BY BMF DATE 11-18-75  
 BOWEN & FEINBERG ASSOCIATES  
 CONSULTING ENGINEERS

<b>TRACO STEEL INC.</b> SANDY SPRINGS, S.C. 29677	
PROJECT: <u>ANDREWS JR. HIGH ADDITION</u>	DATE:
LOCATION: <u>ANDREWS, N.C.</u>	
DWG. COVERS: <u>ROOF FRAMING PLAN</u>	
ARCHT. OR ENGR.: <u>ERIC JOHNSON</u>	
CONTRACTOR: <u>BUNCOMBE COUNTY</u>	
SHOP NOTES:	SHOP PAINT:
DRWN. BY <u>W.G.T.</u>	JOB NO. <u>9-1(0) E-1</u>
CHK. BY:

ROOF FRAMING PLAN

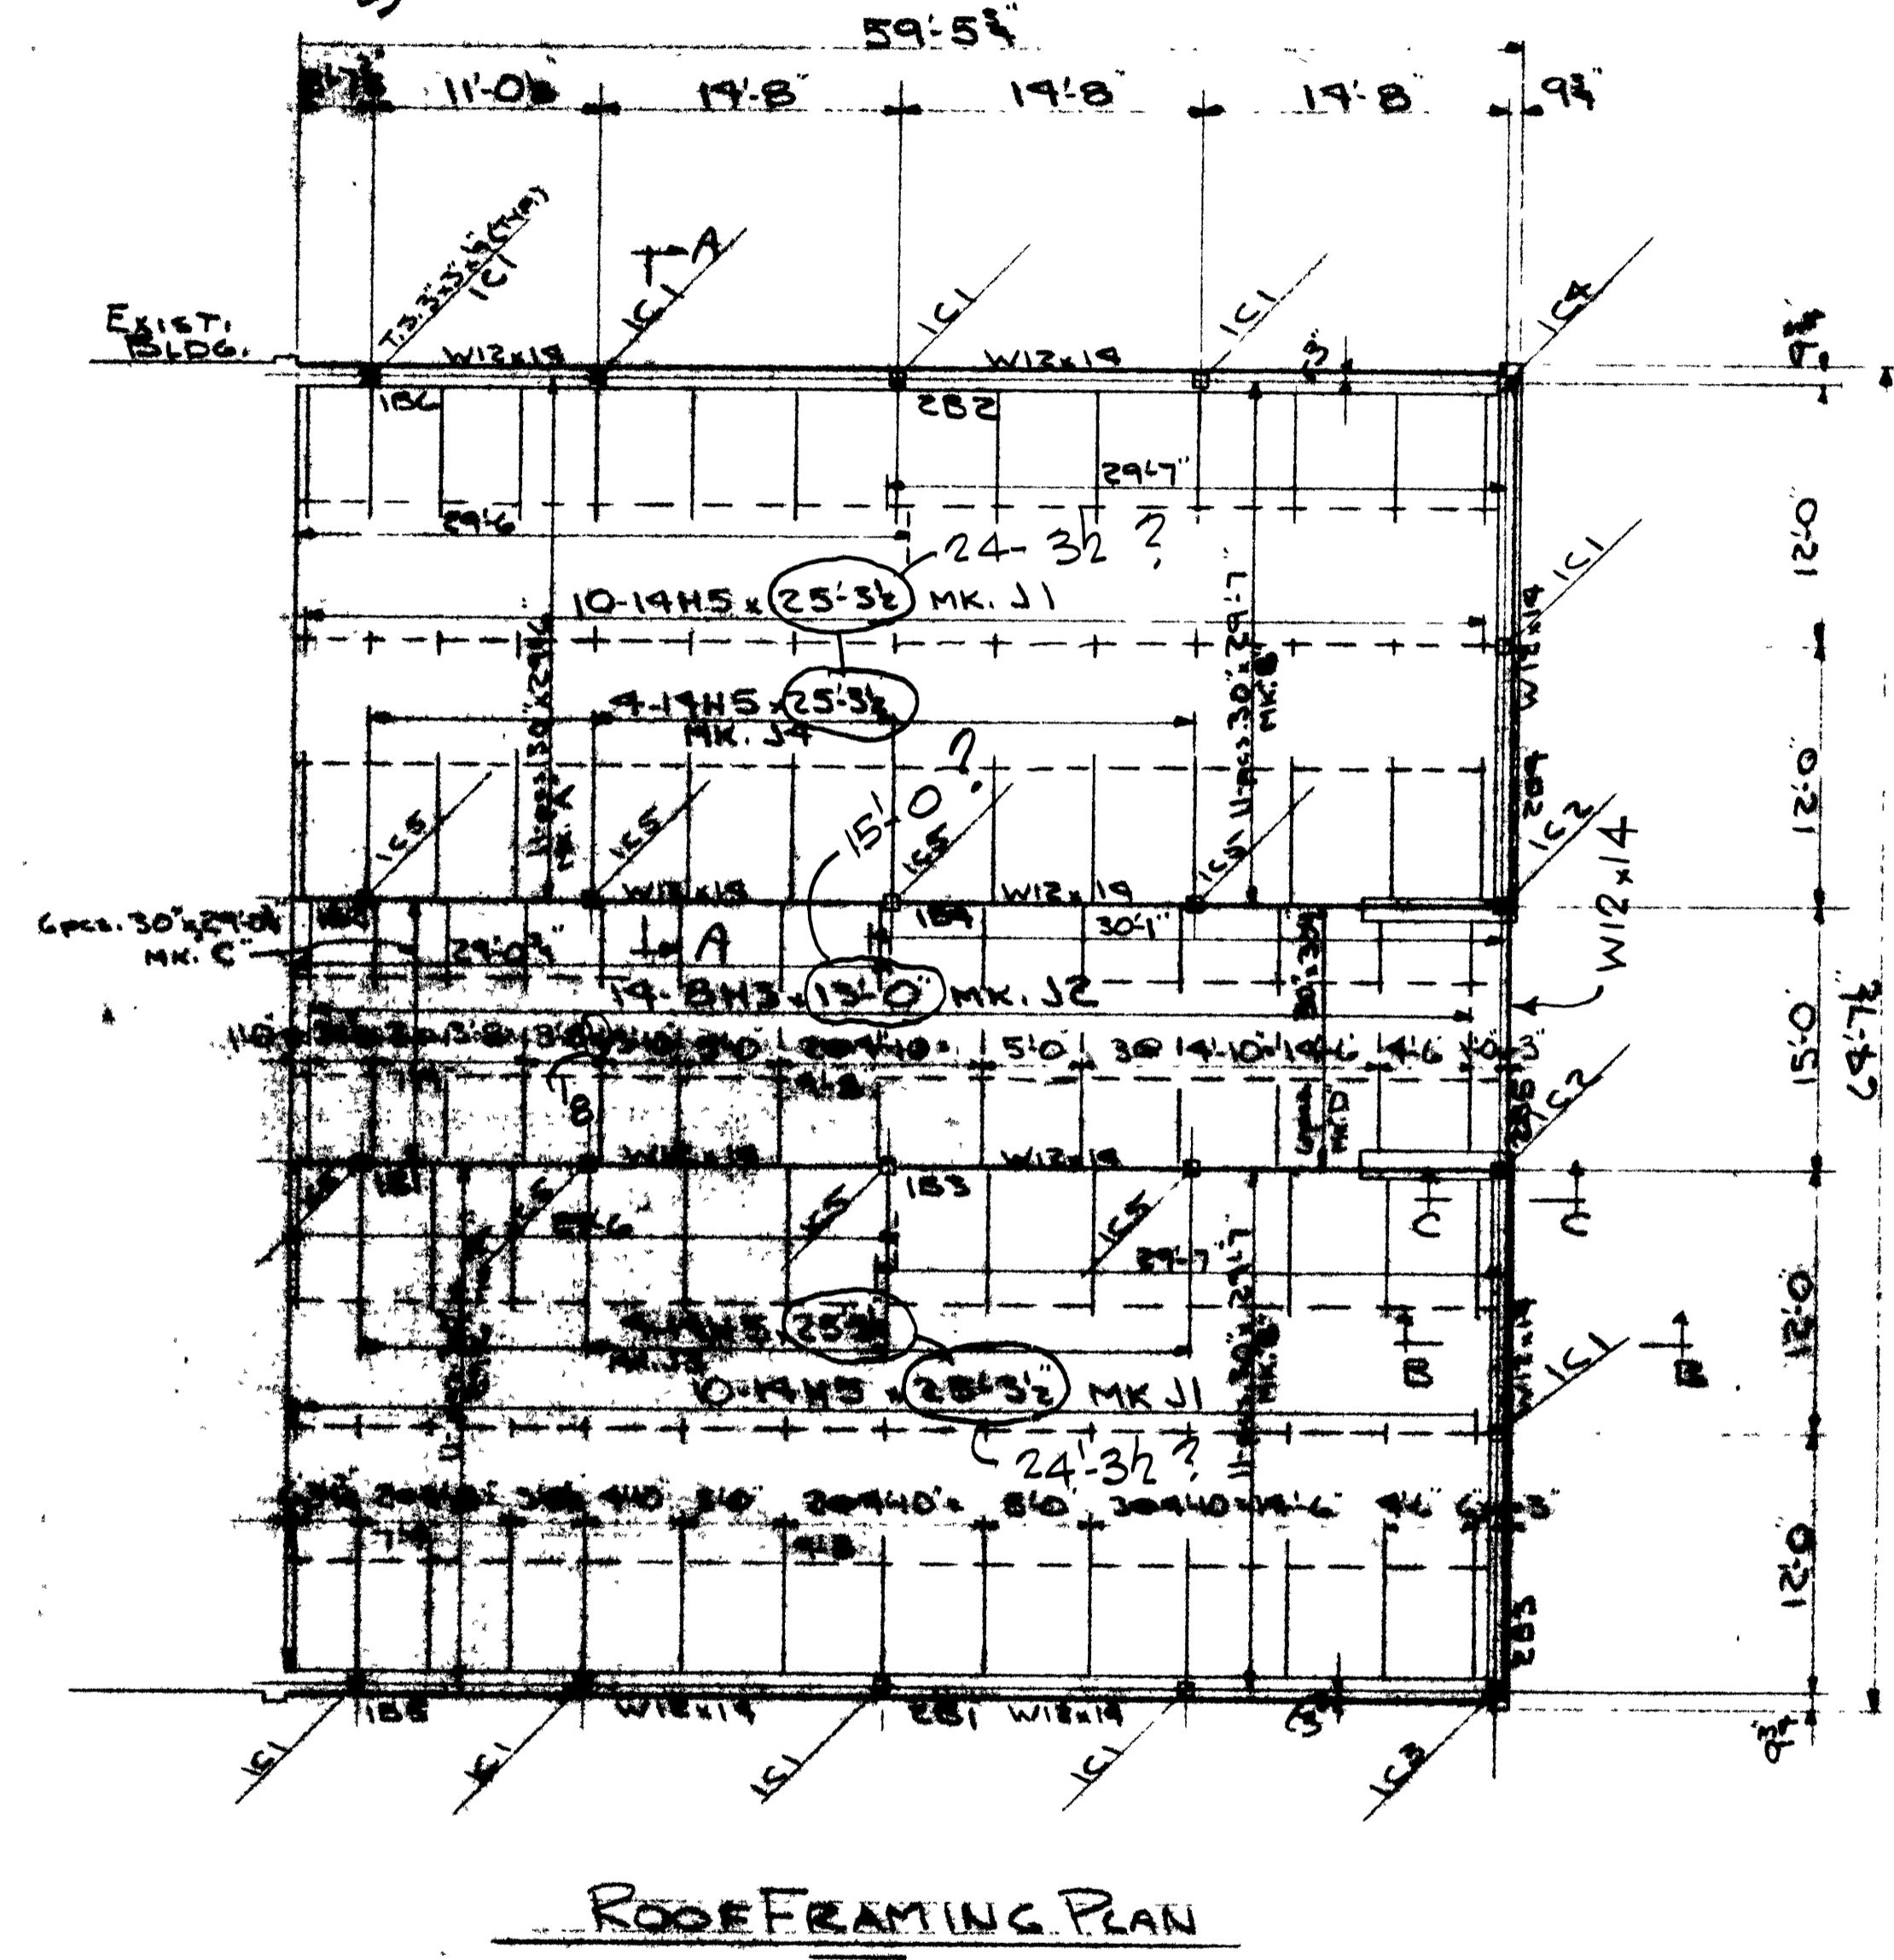
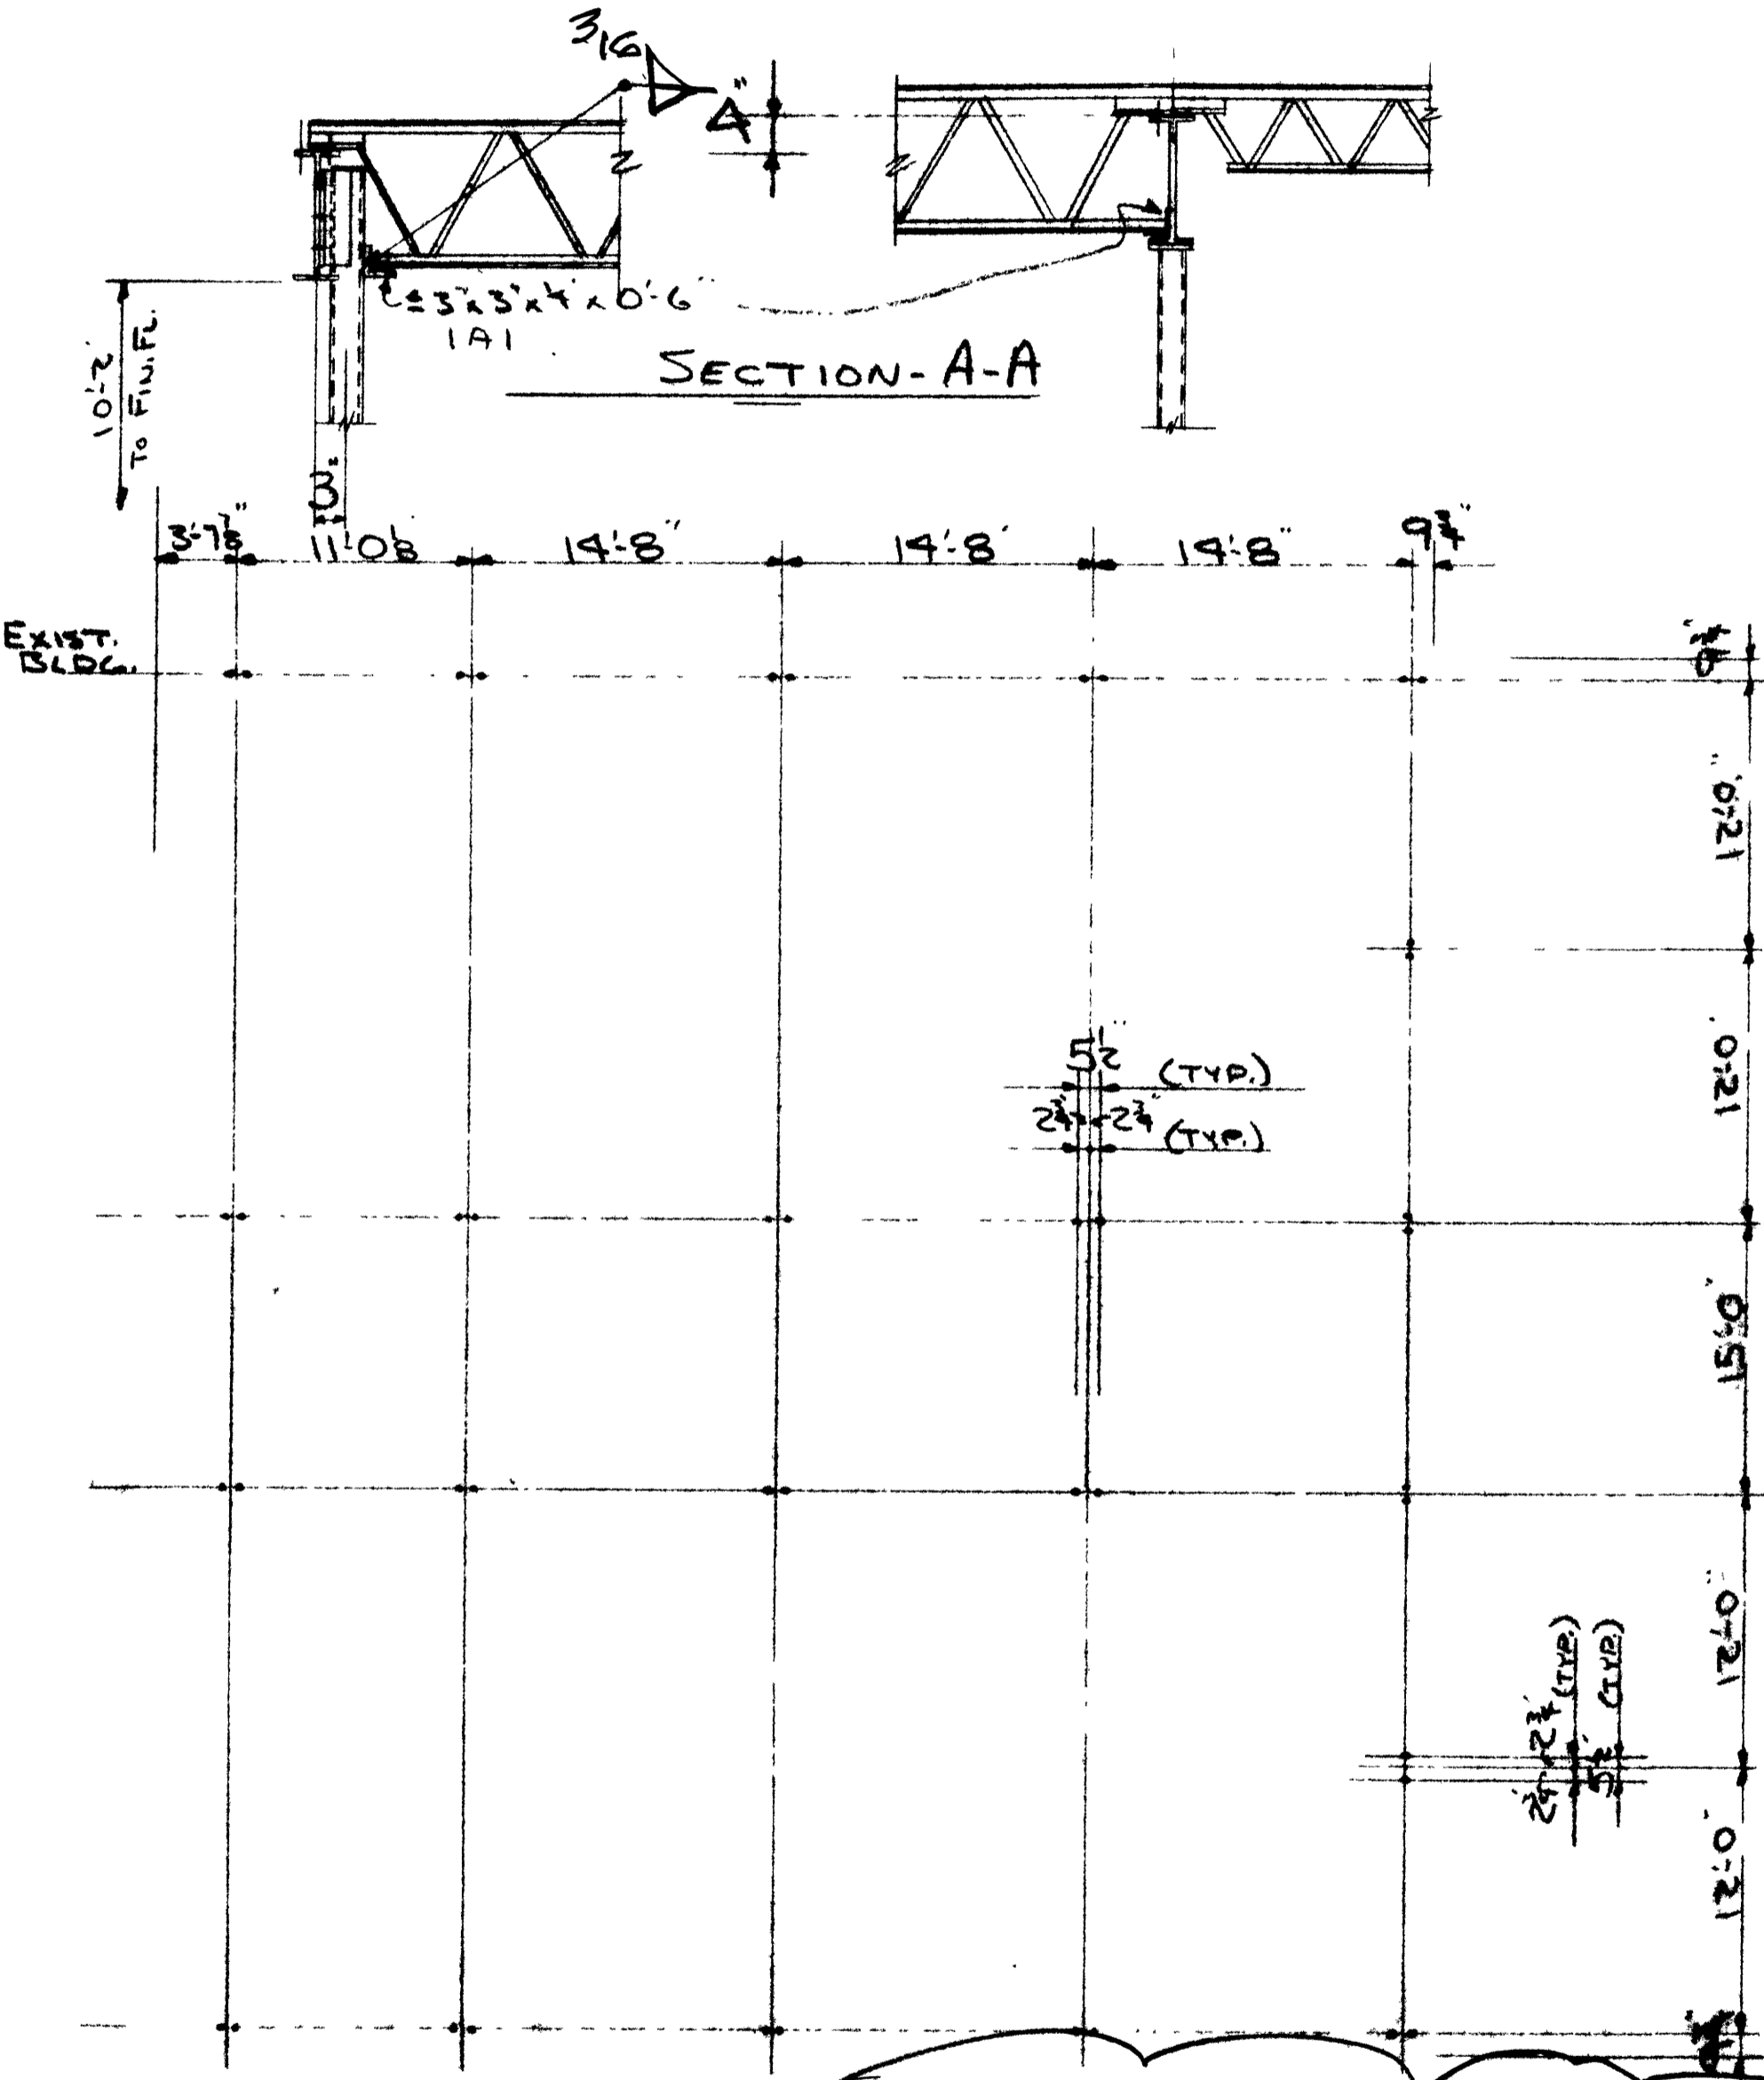
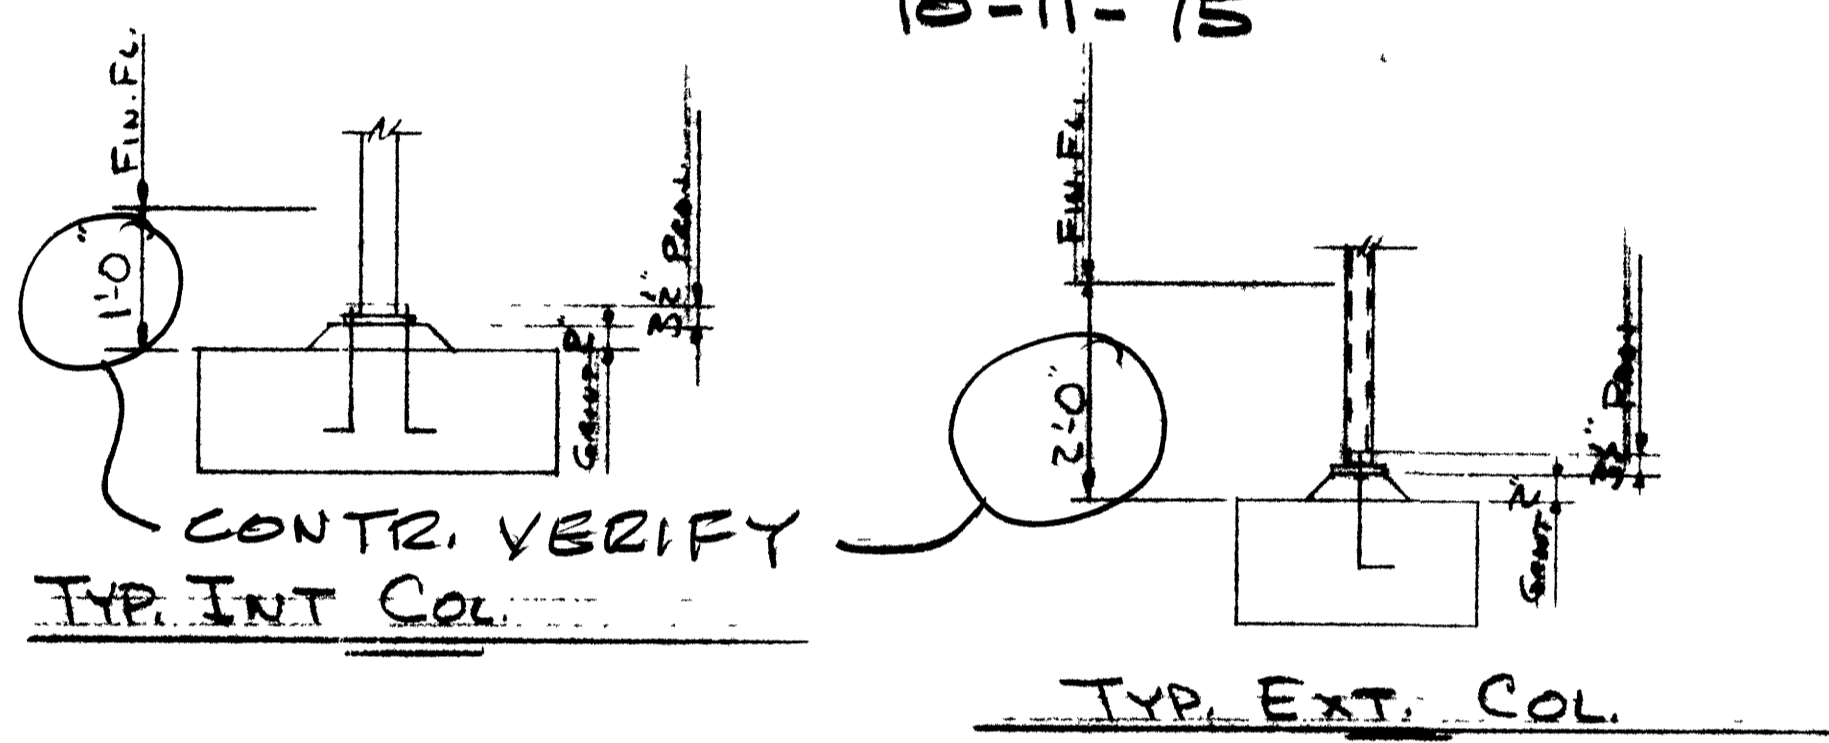
MATERIAL O.K.  
 SUBMIT COMPLETE  
 MANUFACTURERS  
 WELDING INSTRUCTIONS  
 FOR APPROVAL  
 SEE SPECS.

CONTR. VERIFY  
 TYP. INT. COL.

ARCH: PLEASE NOTE  
 REVISED DIM.

TYP. BEAM SPLICE (IF NECESSARY)

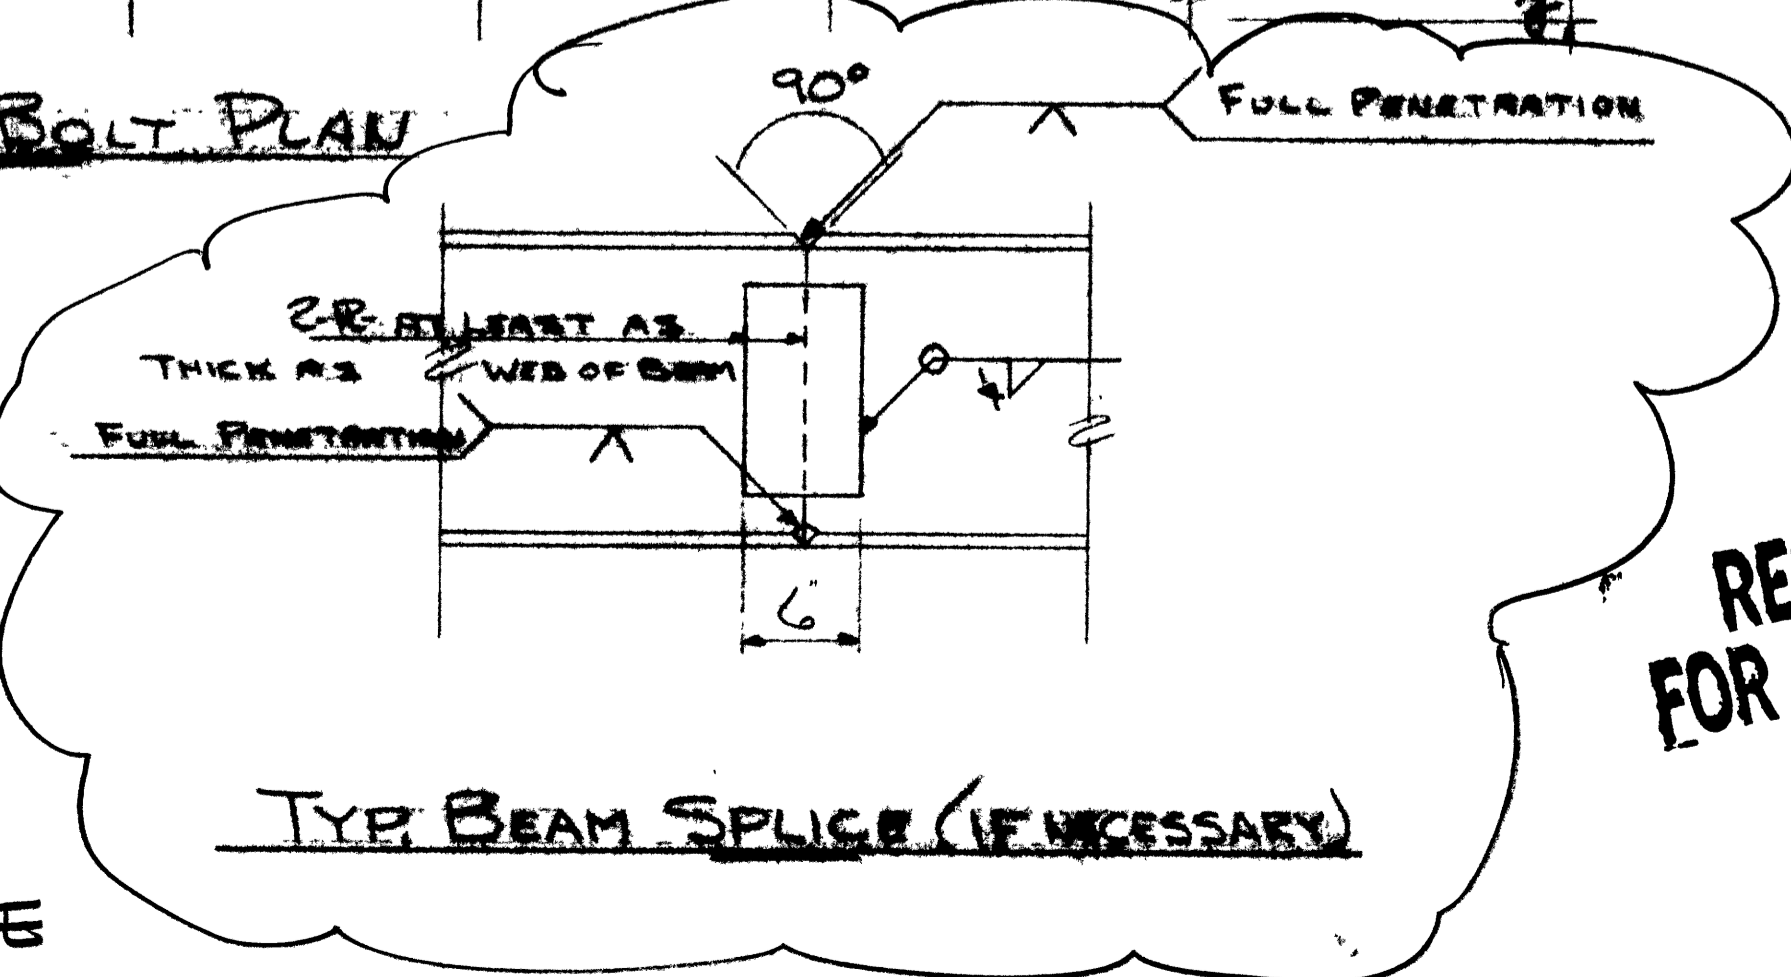
THIS IS STILL NOT  
 ACCEPTABLE!  
 INDICATE EACH SPLICE  
 LOCATION & SUBMIT FOR  
 APPROVAL

RESUBMIT  
 FOR APPROVAL
